Plans Review
Municipality of Mississippi Mills
Building Dept.
2022-08-18

JOB:
PHOENIX HOMES
PNEWD-4
NEWINGTON 'D'
WTR-3 LOT 50
1st Floor Roof Framing

JOB:
PHOENIX HOMES
WHITE TAIL RIDGE
WTR3-50
NEWINGTON D
1ST FLOOR 1 OF 2

NEWINGTON – 2018

SECOND FLOOR PLAN (ELEVATION D)

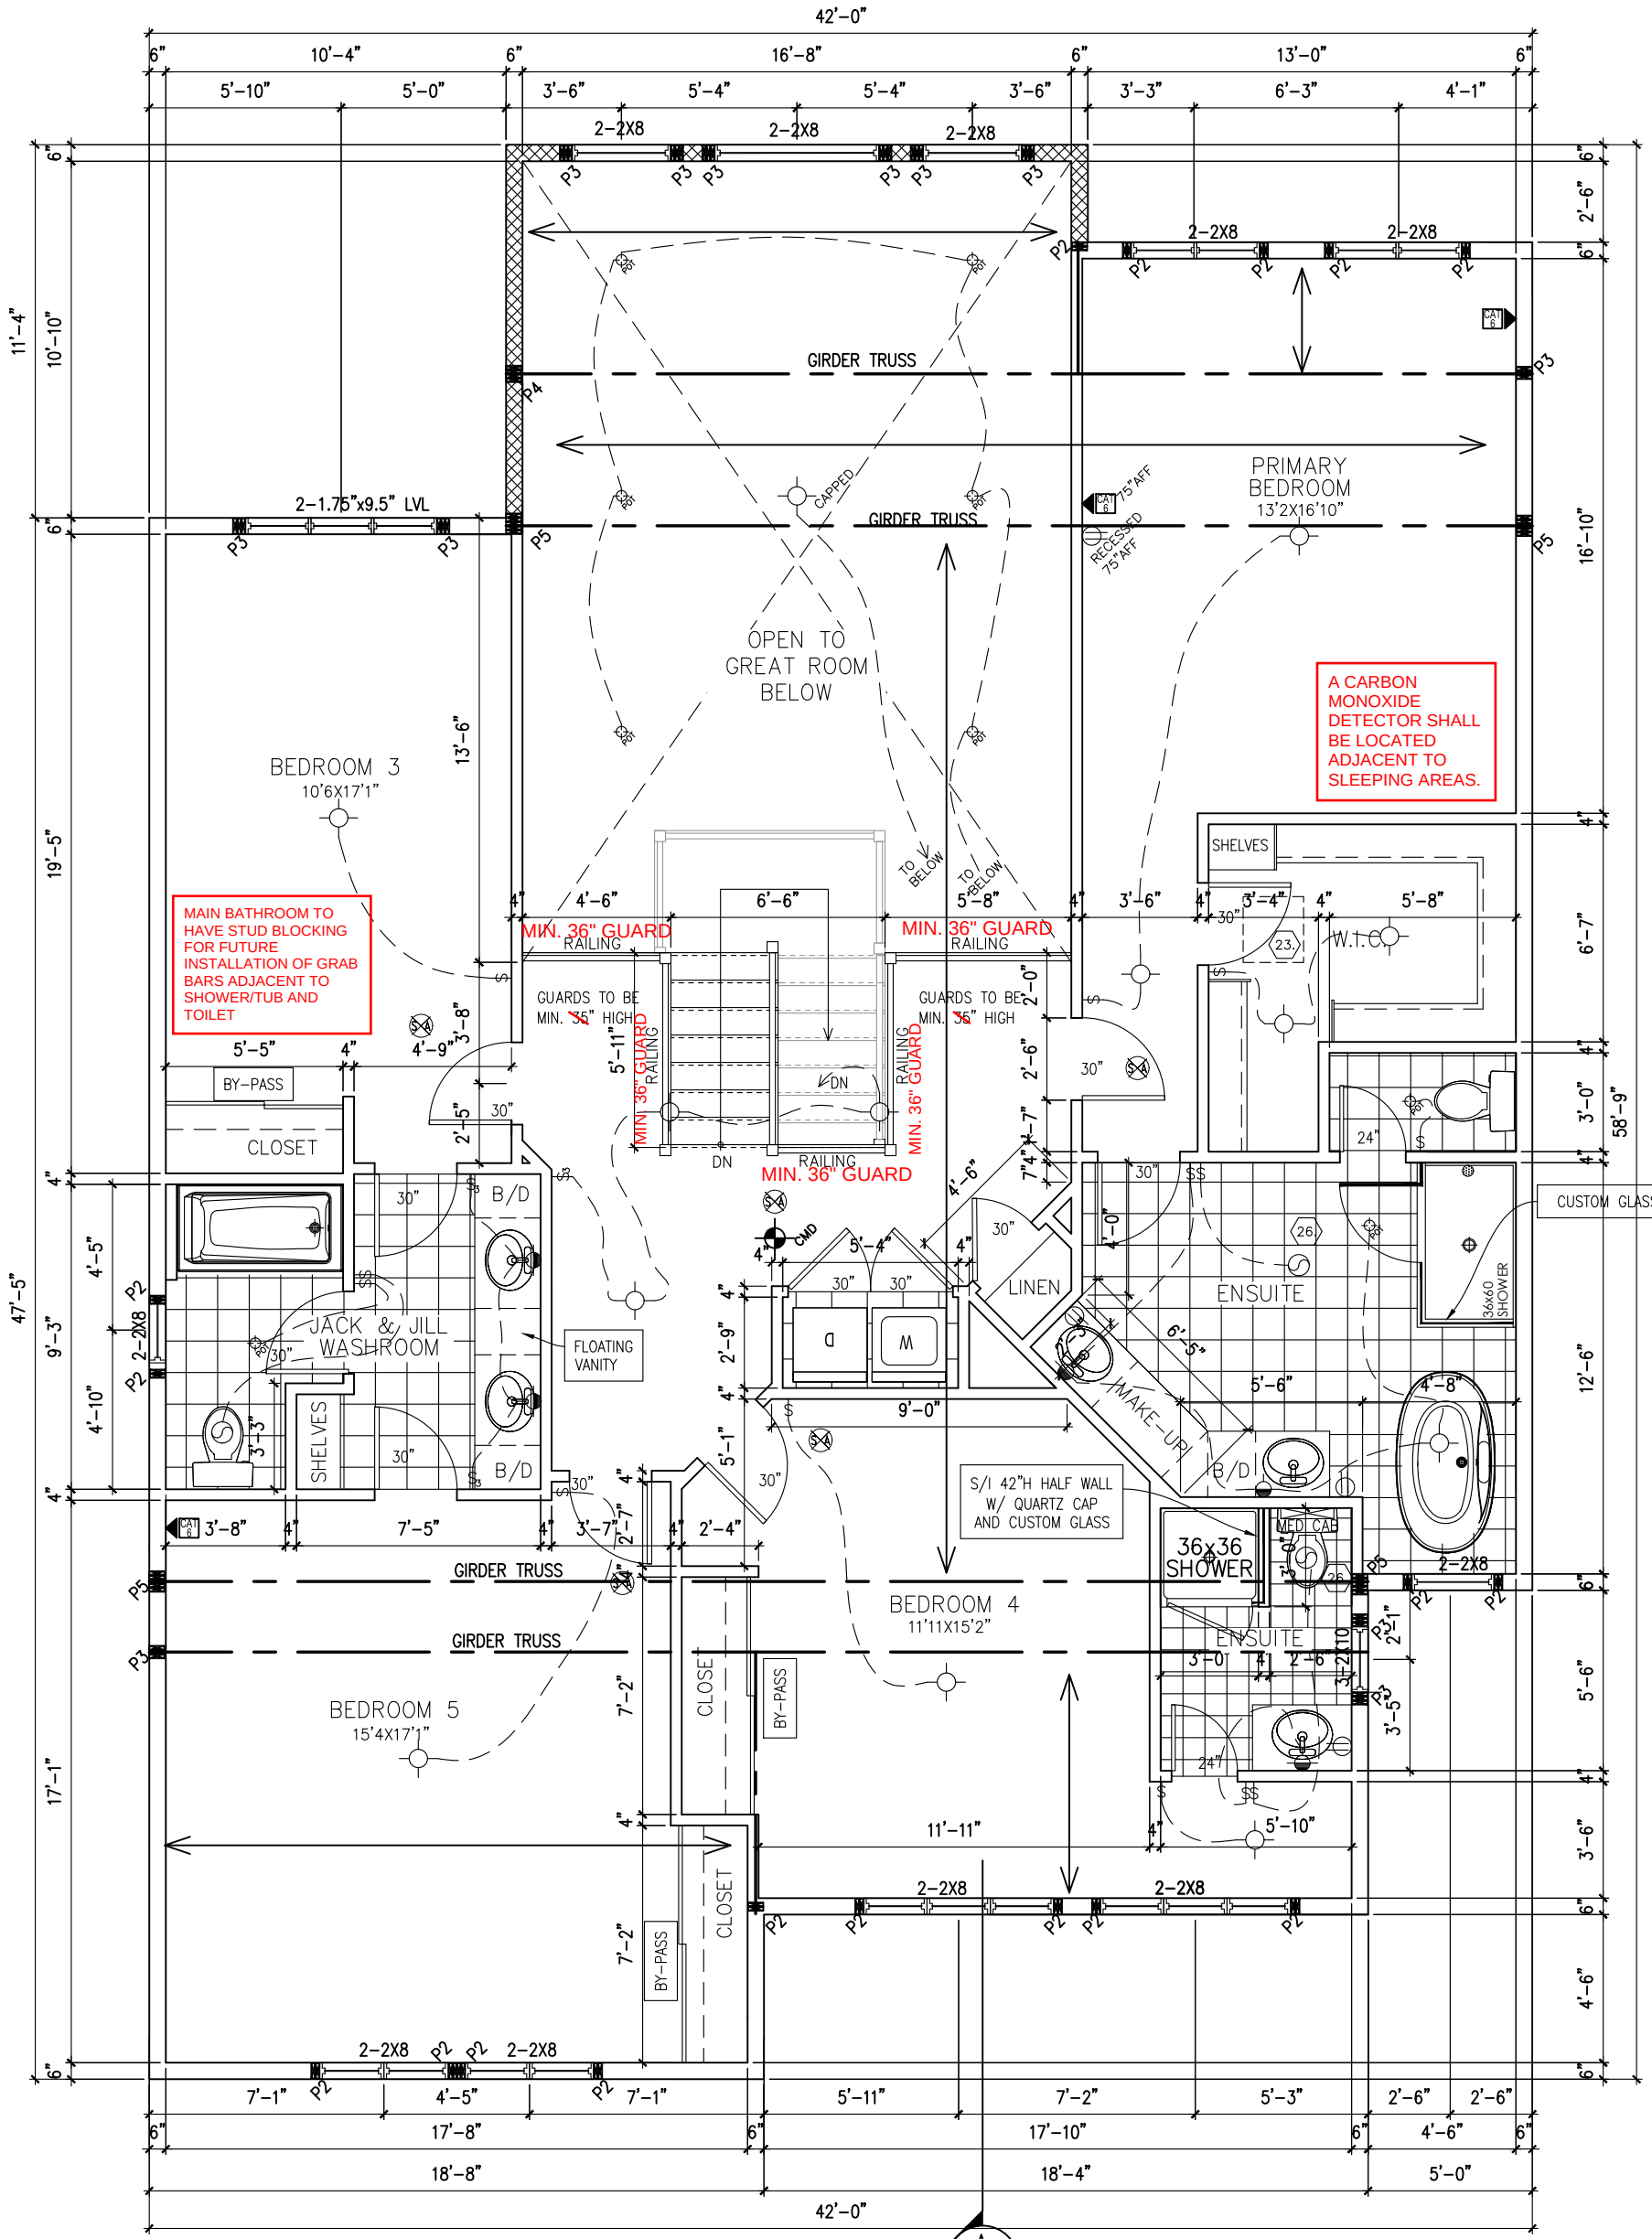
A CARBON MONOXIDE DETECTOR SHALL BE LOCATED ADJACENT TO SLEEPING AREAS.

MAIN BATHROOM TO HAVE STUD BLOCKING FOR FUTURE INSTALLATION OF GRAB BARS ADJACENT TO SHOWER/TUB AND TOILET

ONE WINDOW SHALL PROVIDE AN UNOBSTRUCTED AREA OF 3.8SF w/ NO DIMENSION LESS THAN 15". WINDOW SILL TO BE MAX. 39-3/8" ABOVE FINISHED FLOOR

A SMOKE ALARM SHALL BE INSTALLED ON EACH FLOOR LEVEL AND WITHIN EACH SLEEPING ROOM. ALL SMOKE ALARMS SHALL BE INTERCONNECTED. EACH DEVICE SHALL HAVE A VISUAL SIGNALING COMPONENT IN ADDITION TO THE TEMPORAL PATTERN IN CONFORMANCE WITH 18.5.3 OF NFPA 72.

LEFT SIDE ELEVATION D

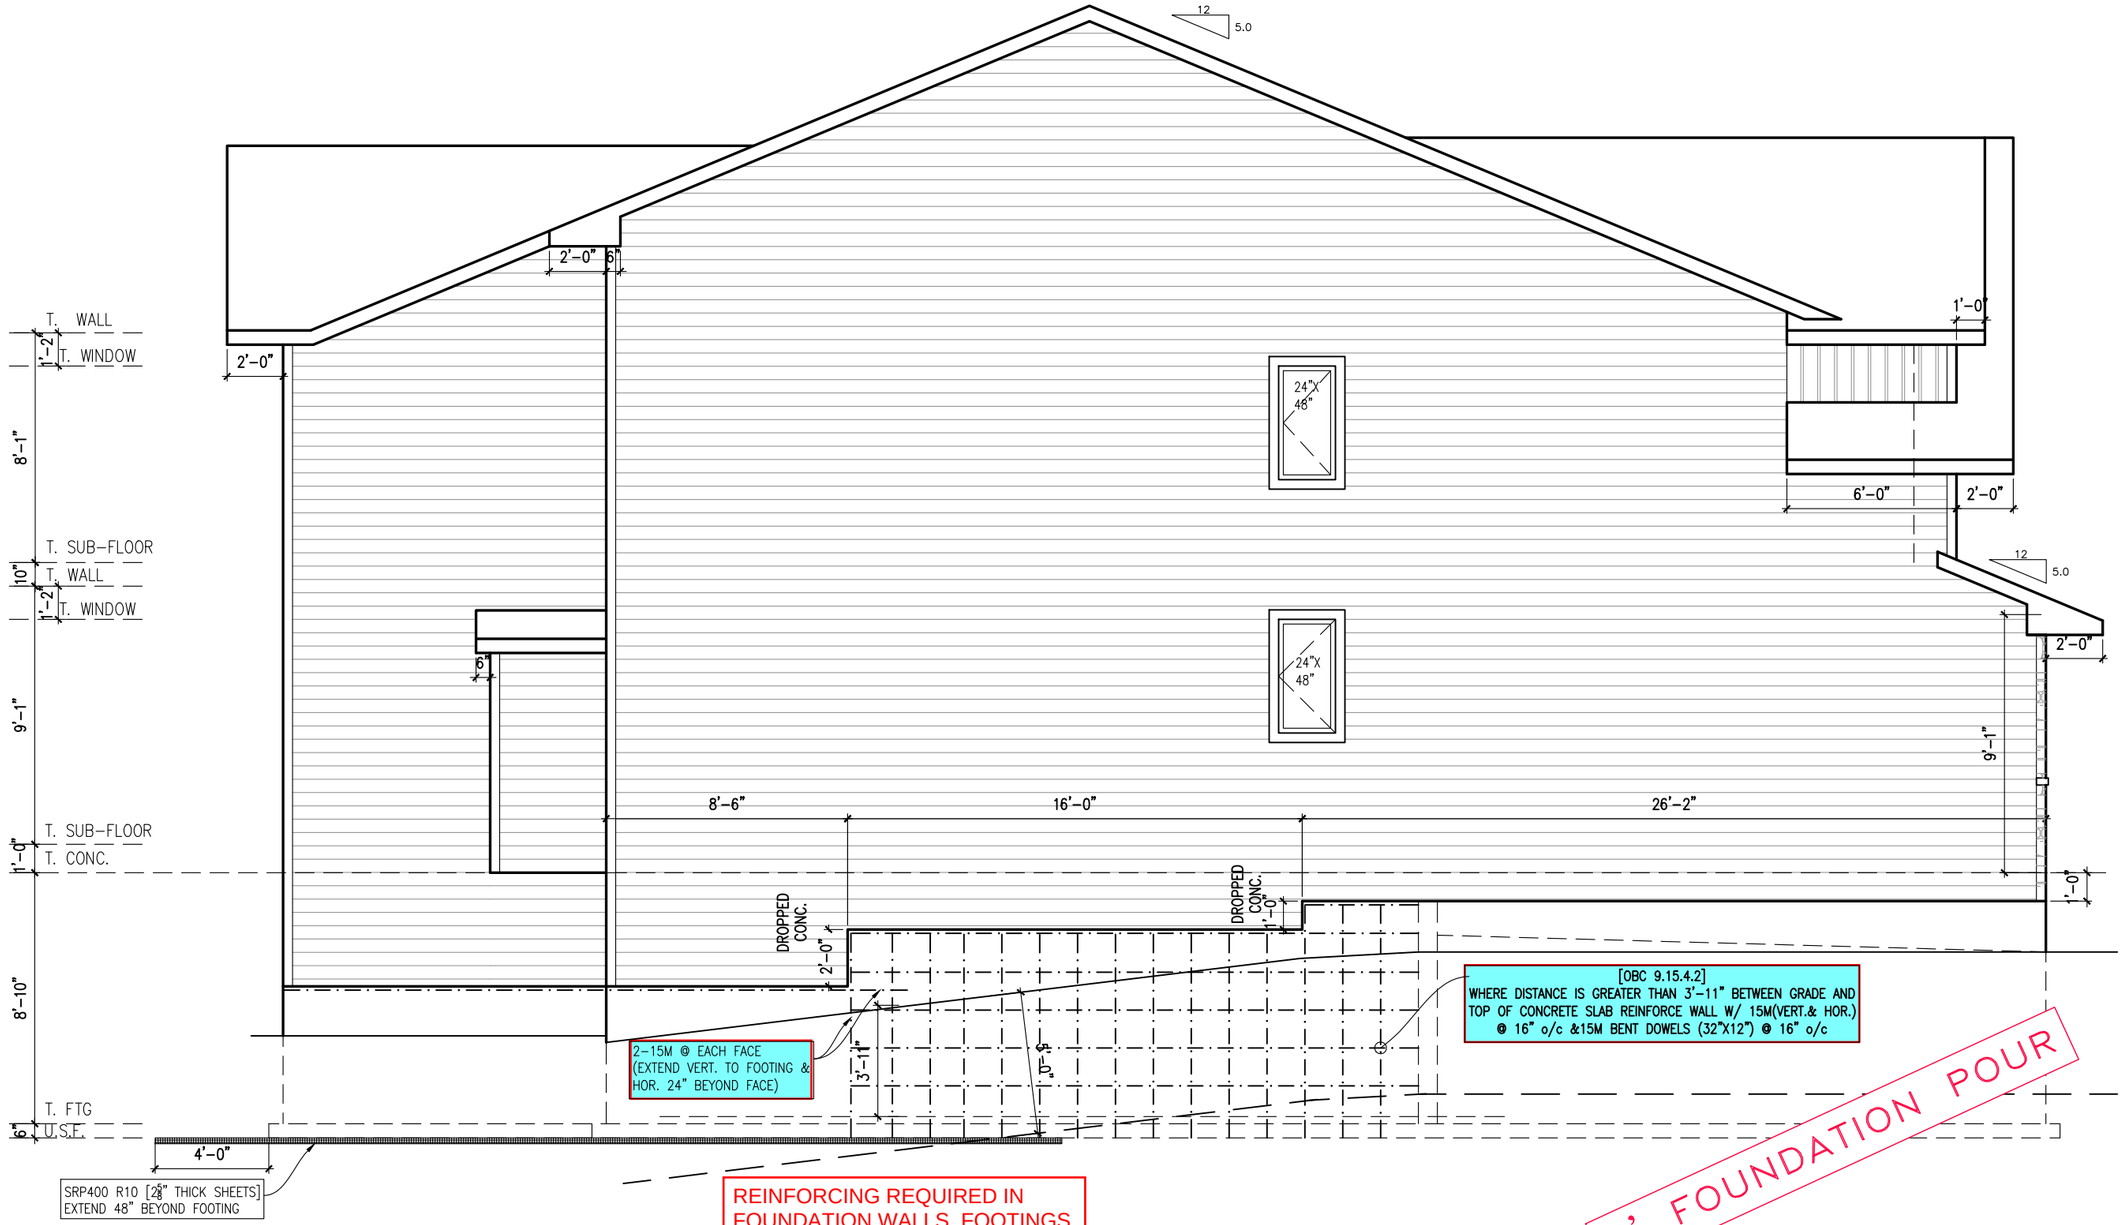
REINFORCING REQUIRED IN FOUNDATION WALLS, FOOTINGS OR PORCH SLAB SHALL BE REVIEWED PRIOR TO POURING CONCRETE (see inspector)

STEP FOOTINGS 9.15.3.9.
VERTICAL RISE NO GREATER THAN 600mm
HORIZONTAL DISTANCE BETWEEN RISERS SHALL BE NO LESS THAN 600 mm

RIGHT SIDE ELEVATION D

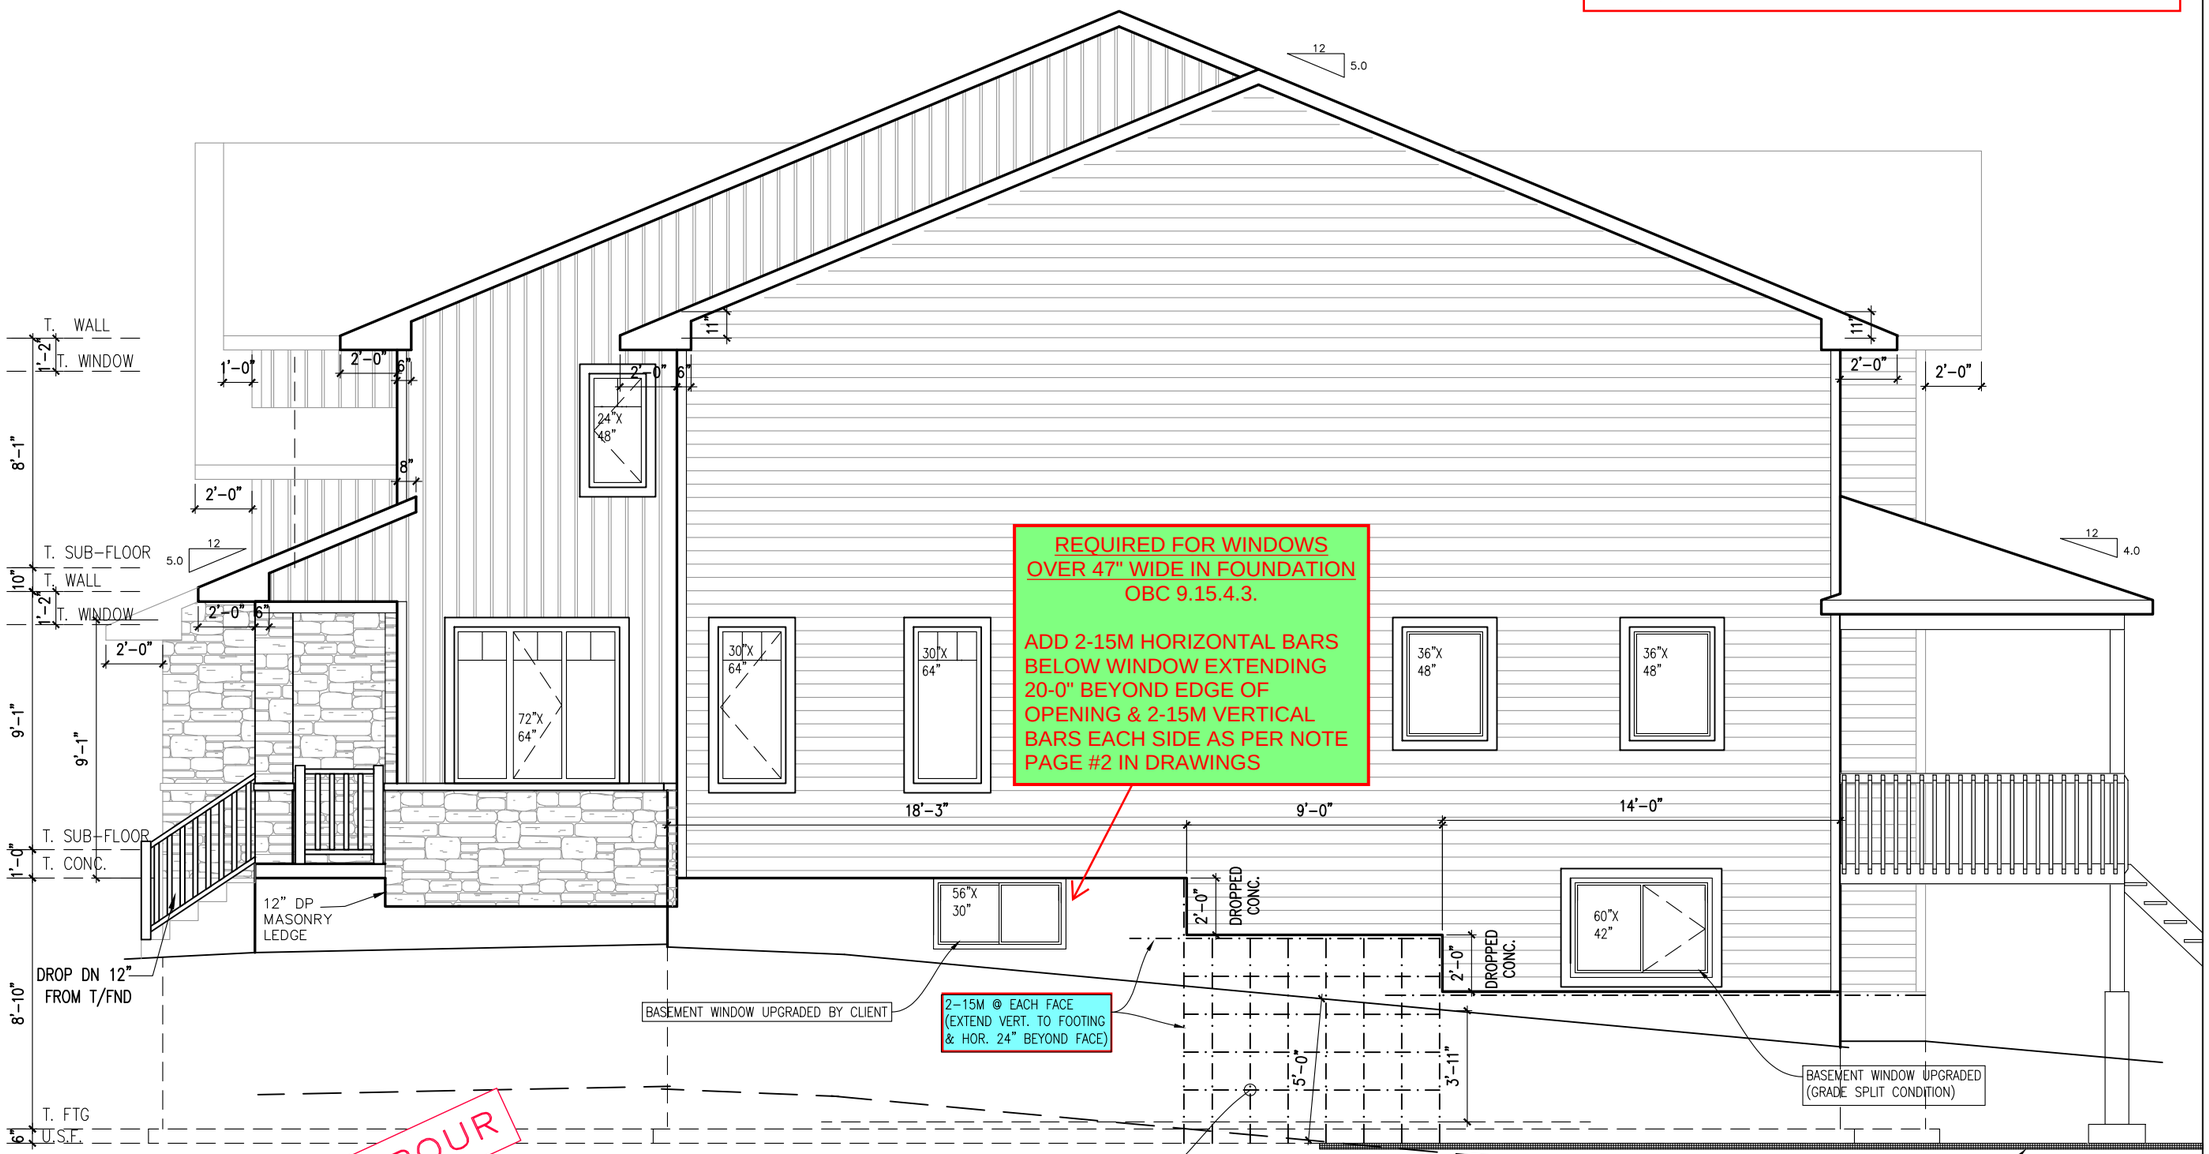
REQUIRED FOR WINDOWS OVER 47" WIDE IN FOUNDATION OBC 9.15.4.3.

ADD 2-15M HORIZONTAL BARS BELOW WINDOW EXTENDING 20-0" BEYOND EDGE OF OPENING & 2-15M VERTICAL BARS EACH SIDE AS PER NOTE PAGE #2 IN DRAWINGS

2-15M @ EACH FACE (EXTEND VERT. TO FOOTING & HOR. 24" BEYOND FACE)

[OBC 9.15.4.2]
WHERE DISTANCE IS GREATER THAN 3'-11" BETWEEN GRADE AND TOP OF CONCRETE SLAB REINFORCE WALL W/ 15M(VERT.& HOR.) @ 16" o/c &15M BENT DOWELS (32"X12") @ 16" o/c

REINFORCING REQUIRED IN FOUNDATION WALLS, FOOTINGS OR PORCH SLAB SHALL BE REVIEWED PRIOR TO POURING CONCRETE (see inspector)
